Subject: Class 3 Permit Modification Request, Construction and Use of Hazardous Waste Disposal Units 11 and 12 for the Waste Isolation Pilot Plant Hazardous Waste Facility Permit Number: NM4890139088-TSDF

Class 3 Permit Modification Request

Construction and Use of Hazardous Waste Disposal Units 11 and 12

**Waste Isolation Pilot Plant
Carlsbad, New Mexico**

Figure G-1
Location of Underground HWDUs and WPC Locations

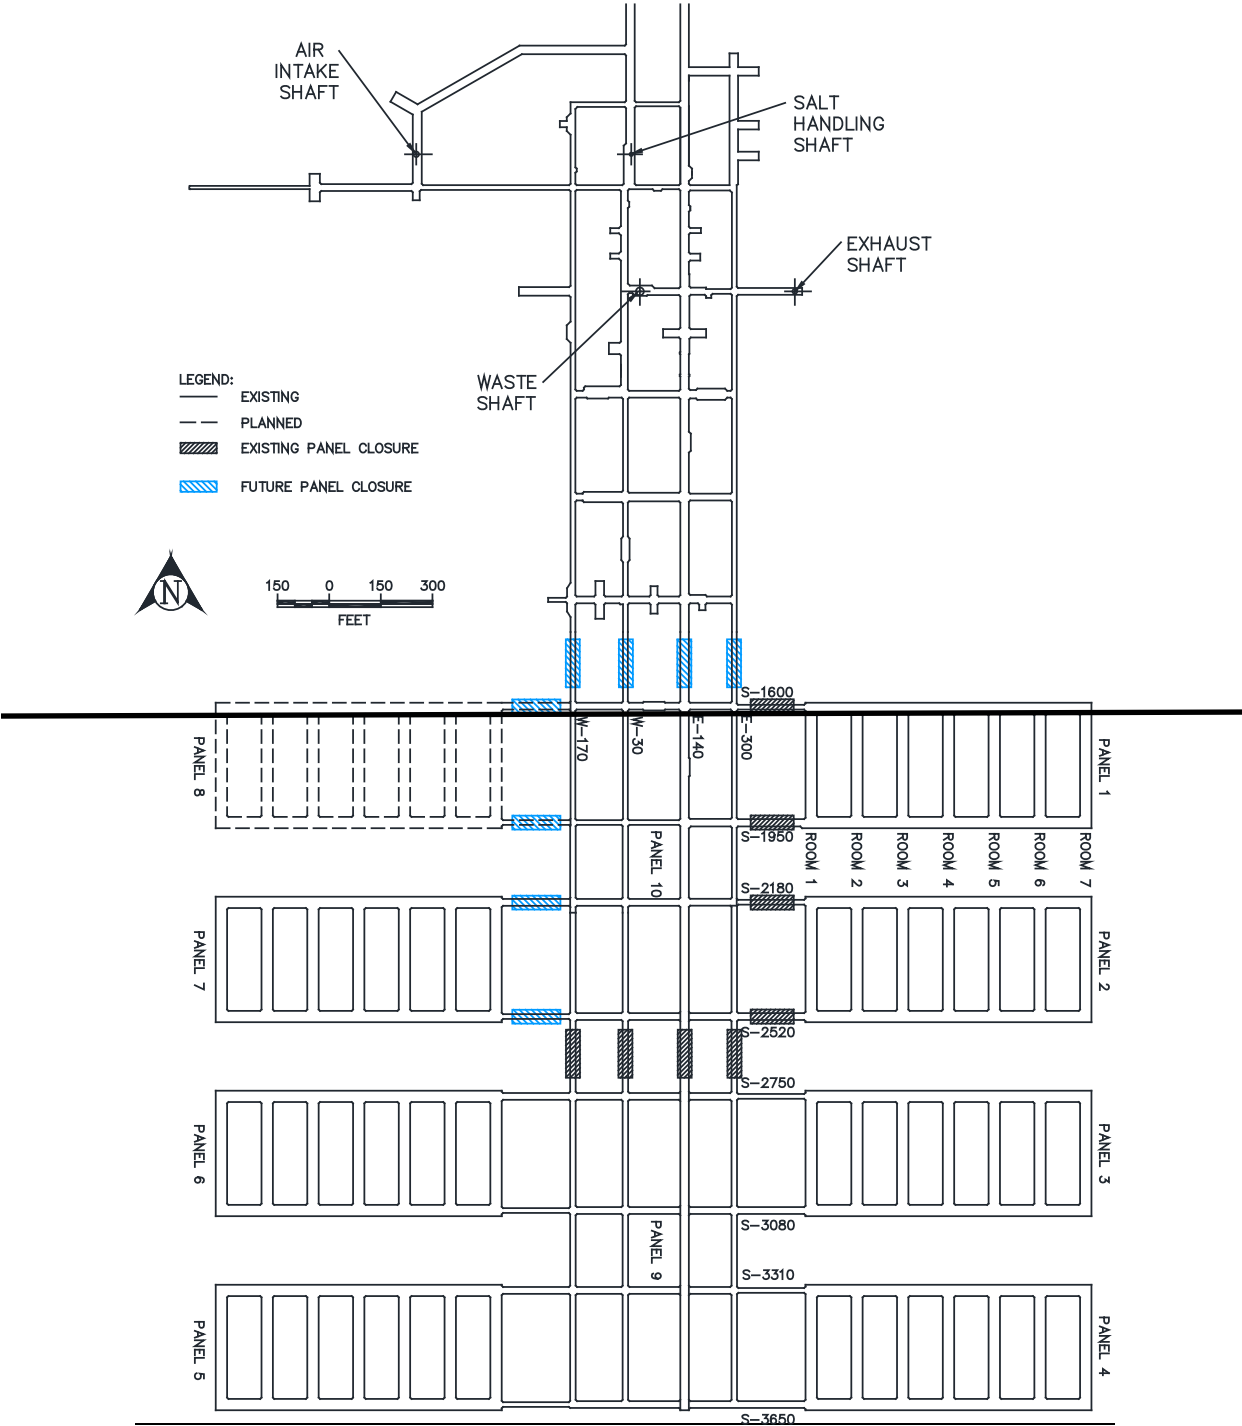
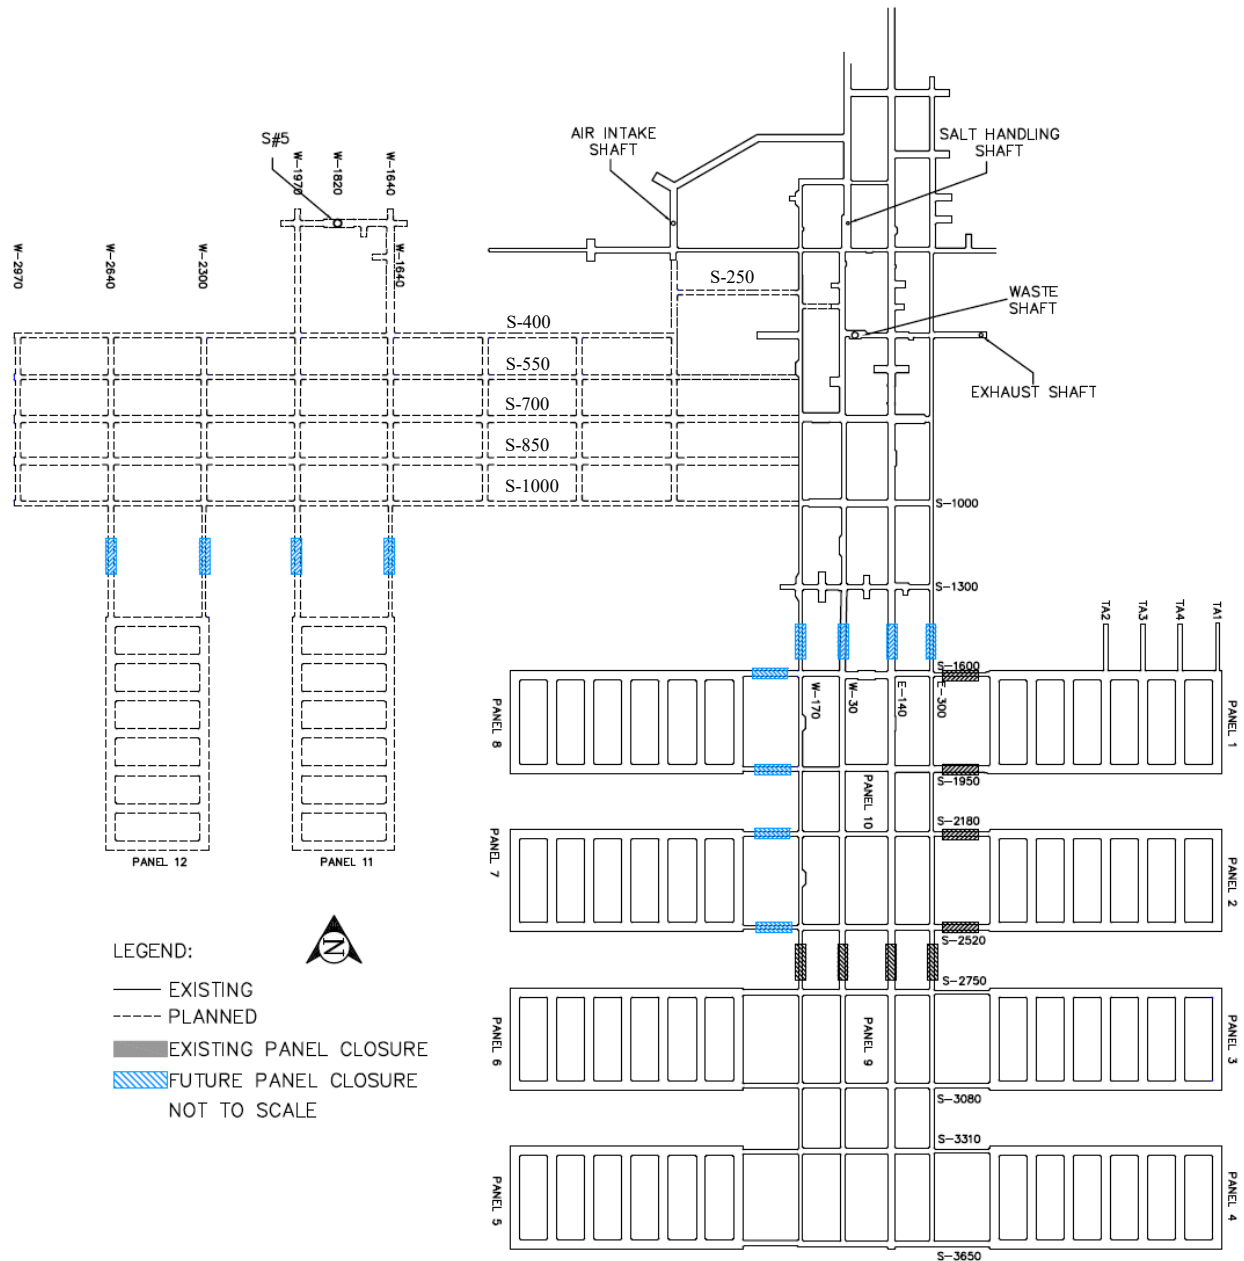
- Permit Attachment G, Figure G-1, *Location of Underground HWDUs and WPC Locations*, is being modified to include the location of the West Mains and Panels 11 and 12.

Attachment G, Figures	Modified Figure G-1, <i>Location of Underground HWDUs and WPC Locations</i> , and G-6, <i>Approximate Locations of Boreholes in Relation to the WIPP Underground</i> , to show the location of the West Mains and Panels 11 and 12. This change is needed to accurately describe the layout of the underground repository.
Attachment G, Figures	Modified Figure G-5, <i>Typical Disposal Panel</i> , to show the difference in the length of Panels 1-8 and Panels 11 and 12 based on the increased abutment pillar for Panels 11 and 12. Also modified the A-A' cross section to show the height of the disposal room as 13-14 feet. This modification is needed to accurately depict the panel dimensions.
Attachment G, Figures	Modified Figure G-6, <i>Approximate Locations of Boreholes in Relation to the WIPP Underground</i> , to show the location of the West Mains and Panels 11 and 12. This change is needed to accurately describe the layout of the underground repository.

Attachment G, Figure G-1	Replaced figure to show the West Mains and Panels 11 and 12 along with the future panel closure locations.
Attachment G, Figure G-5	Replaced figure to show that the length of a typical panel is 1,021'-6" for Panels 1-8 and 1,221'-6" for Panels 11 and 12. Also modified the A-A' section to show the disposal room height at 13'-14'.
Attachment G, Figure G-6	Replaced figure to show the West Mains and Panels 11 and 12 for accuracy of the repository layout.
Attachment G1, Section G1-1	Panels 11 and 12 were added to the description of panels in the first paragraph.
Attachment G1, Section G1-2	Added Panels 11 and 12 to the sentence describing where the WPC-A design is intended to be used.
Attachment G1, Section G1-2b	Added Panels 11 and 12 to the first sentence of the 2 nd paragraph, describing where the WPC-A is to be used.
Attachment G2, Figure G2-1	Replaced the figure with a figure showing the Panels 11 and 12 as well as the West Mains, and to make consistent with similar spatial view figures in the Permit.

Figure G-5
Typical Disposal Panel

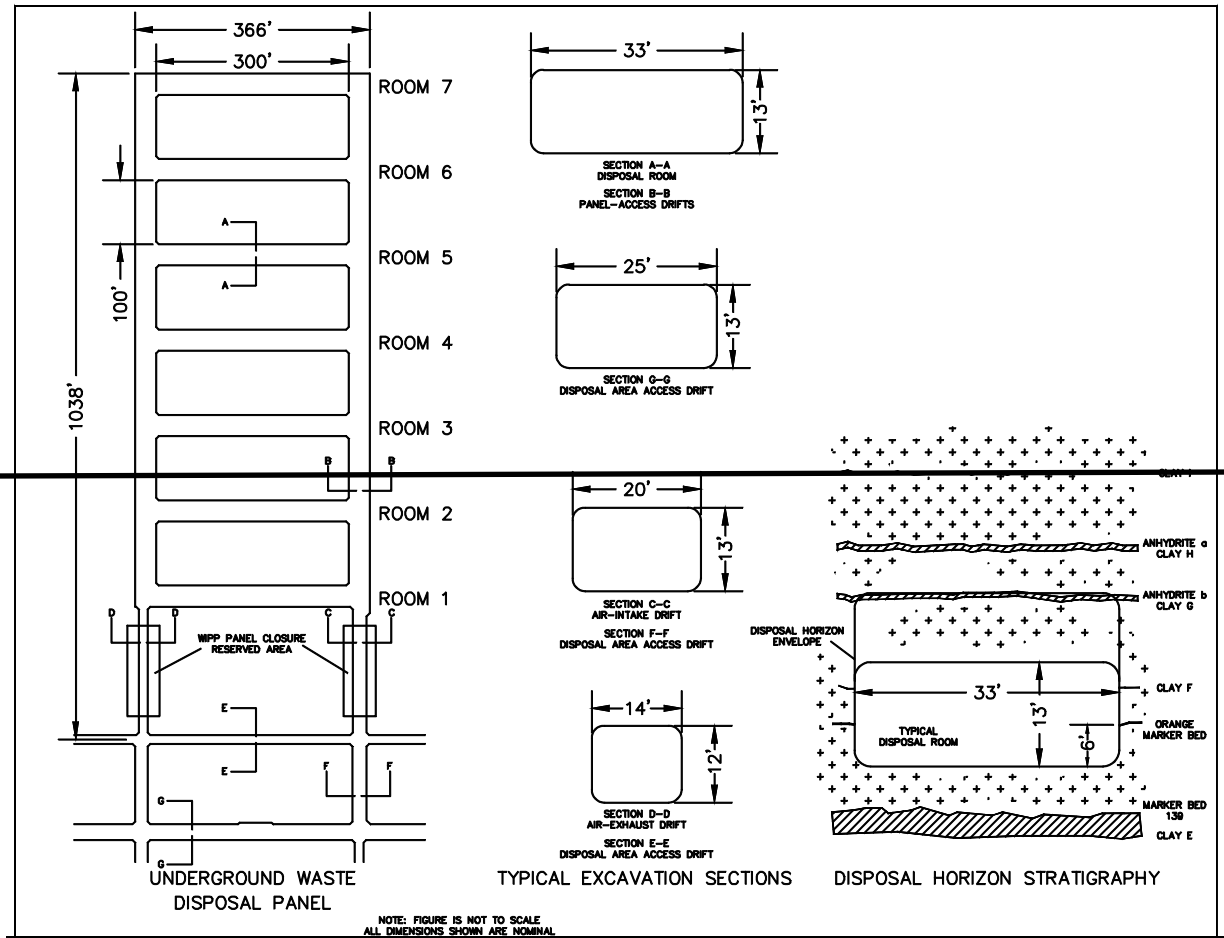
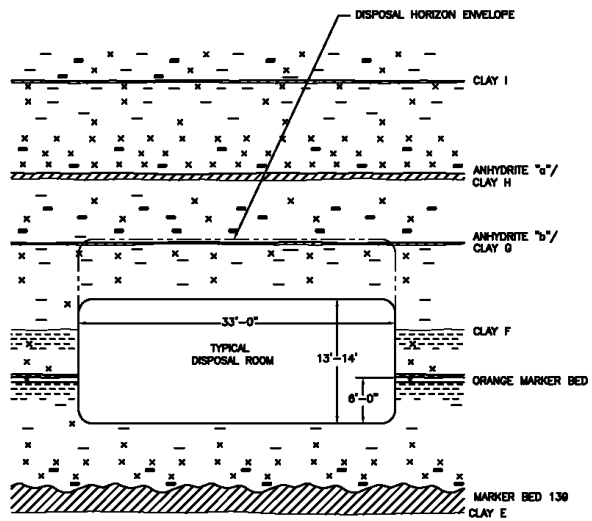
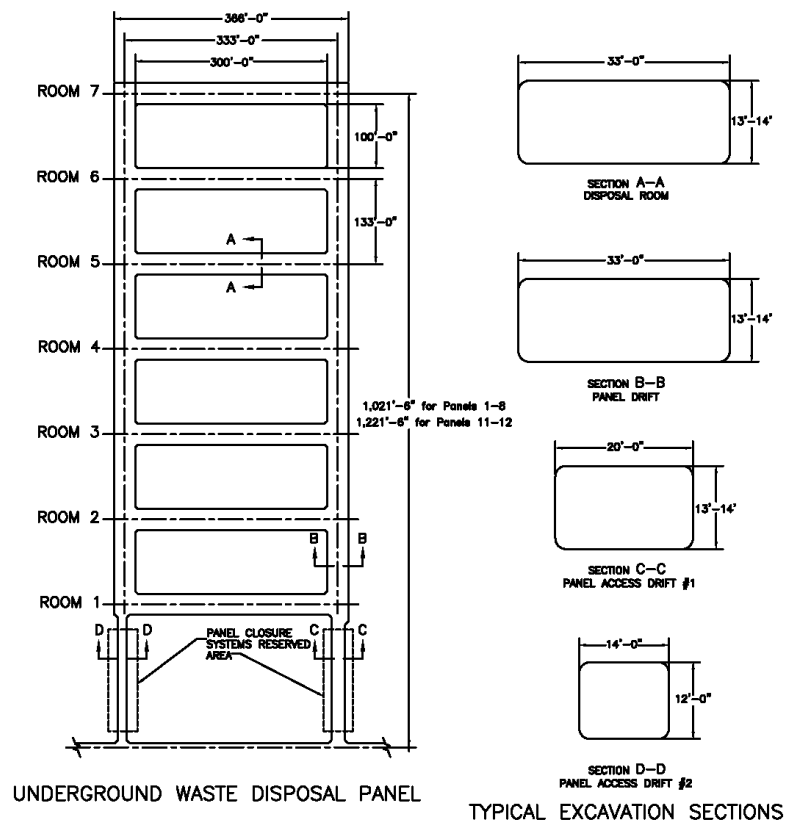
- Permit Attachment G, Figure G-5, *Typical Disposal Panel*, is being modified to show the length of the panel, including the abutment pillar, for Panels 1-8, as well as for Panels 11 and 12. Additionally the height of the disposal rooms and intake drifts is being modified on the figure to show that the nominal height is in a range of 13 ft-14 ft.

Figure G-6
Approximate Locations of Boreholes in Relation to the WIPP Underground

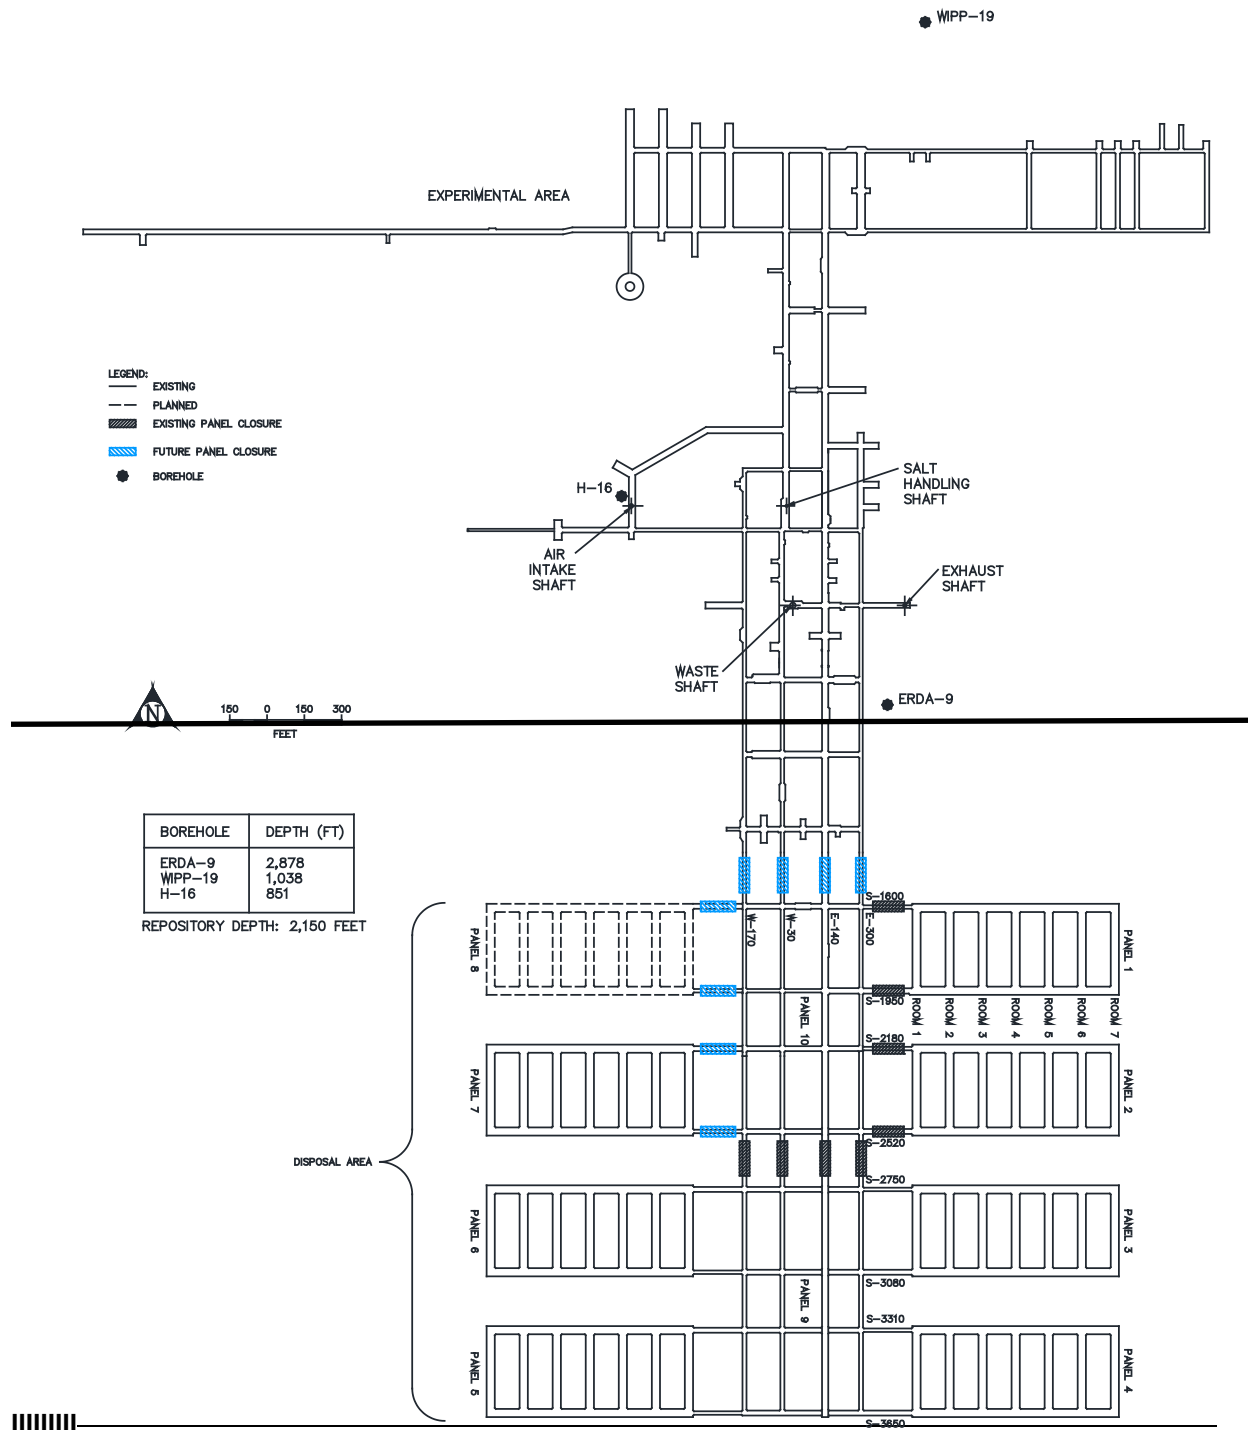
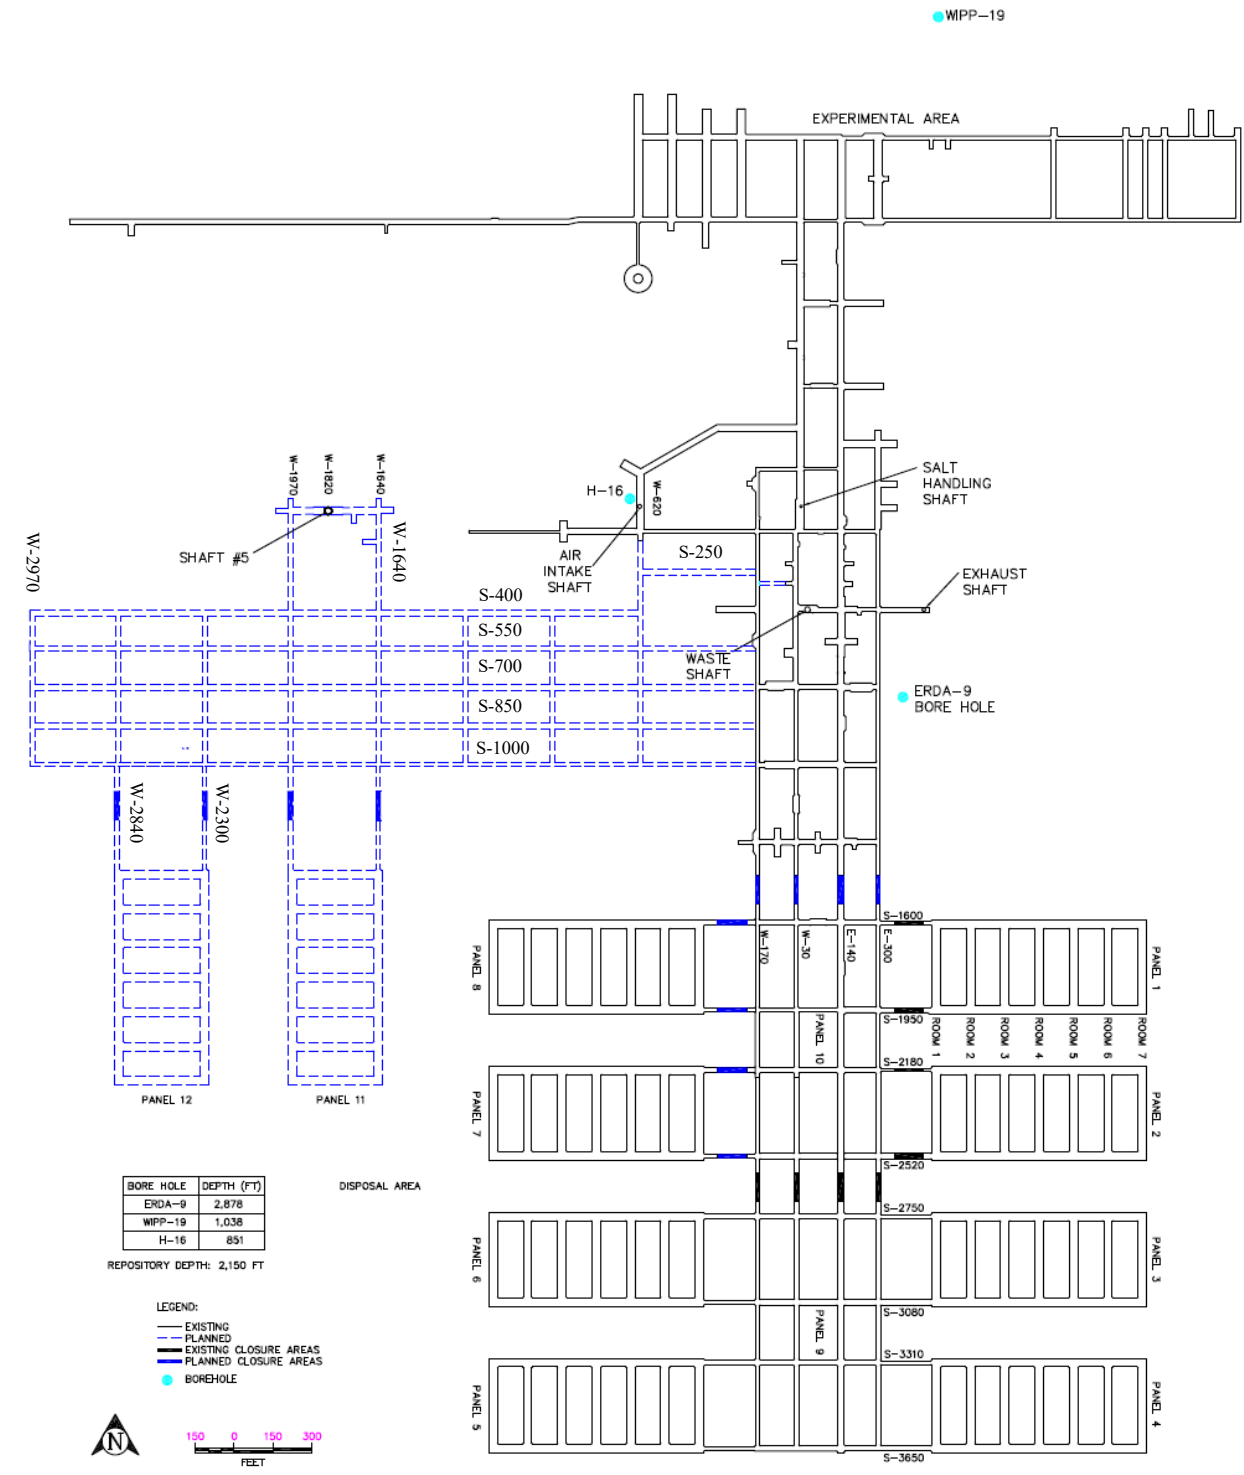
- Permit Attachment G, Figure G-6, *Approximate Locations of Boreholes in Relation to the WIPP Underground*, is being modified to include the location of the West Mains and Panels 11 and 12.
